To: T10 Committee (SCSI)

From: George Penokie (IBM/Tivoli)

Subject: SAM-4: Converting to UML part 1

Figure 4 — Logical unit class diagram

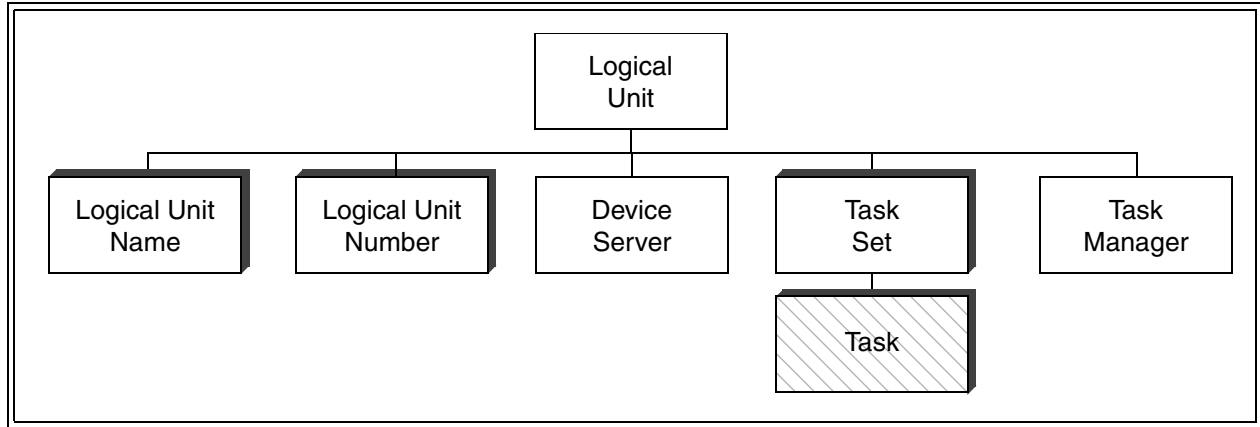
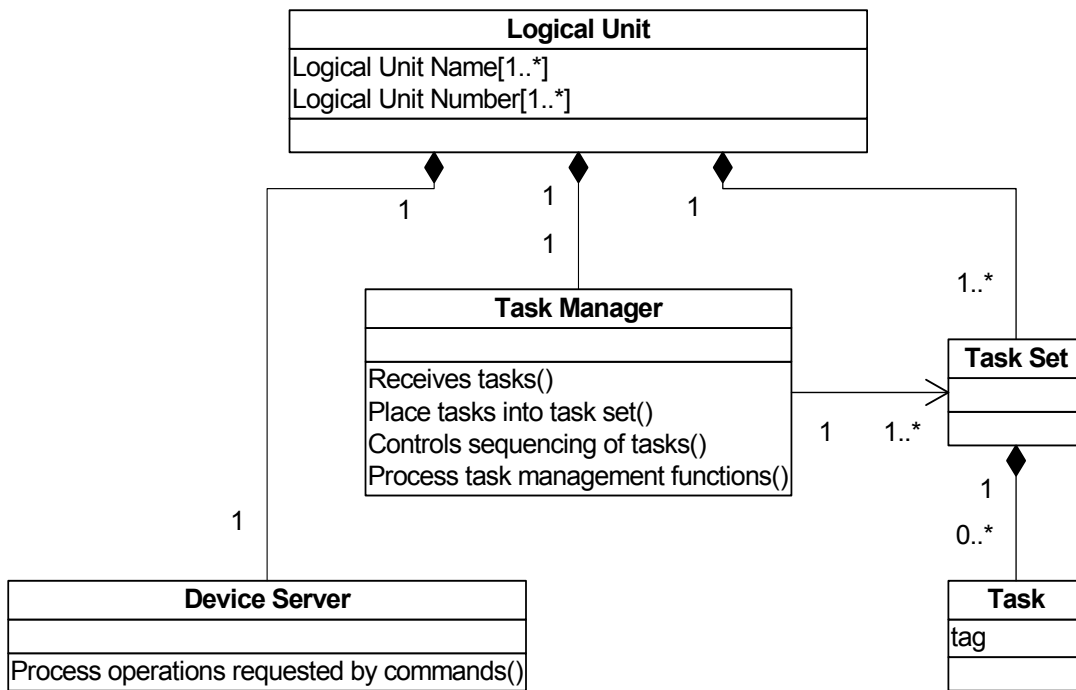
For an example of what figures in SAM-4 would look like a converted logical unit model (see figure 3) as currently shown in SAM-4 would look like what is shown in figure 4.
